Office Action Summary	Application No.	Applicant(s)	
	10/584,407	BROOKS, PAUL JOSEPH	
	Examiner	Art Unit	
	APRIL C. INYARD	1794

DETAILED ACTION

This second non-final action is in response to Applicant's amendments filed on 03/12/2009.

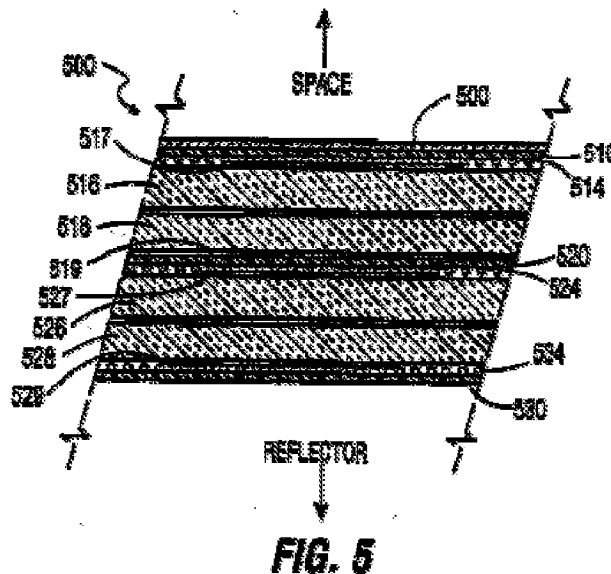
The multi-layered film that satisfies the above requirements as disclosed in Fig. 5 by Lepore (*Col 7, lines 1-38*) has black polyimide dielectric films (labeled elements 510, 520, and

530) bonded with glass fiber reinforcement mesh films between (labeled elements 514, 524, 534), quartz fiber mats (516, 518, 526, 528) to provide increased radiation isolation, and a single germanium coating layer (labeled element 512, on the space facing surface of film 510):

Lepore teaches that black polyimide minimizes transmittance and RF transmission losses through the membrane (*Col 4, lines 58-66*).

The polyimide dielectric films, glass and quartz fiber reinforcement multi-layer stack is considered to thus correspond to a multi-layered filter with alternating high and low refractive indices.

The Examiner takes the position that germanium, a known metalloid, is a nonmetal as evidenced by *Merriam-Webster*, where metalloids are intermediate in properties between metals and nonmetals, but are considered nonmetals that can combine with a metal to form an alloy. Therefore, the thermal control film taught by Lepore is considered to be metal free.
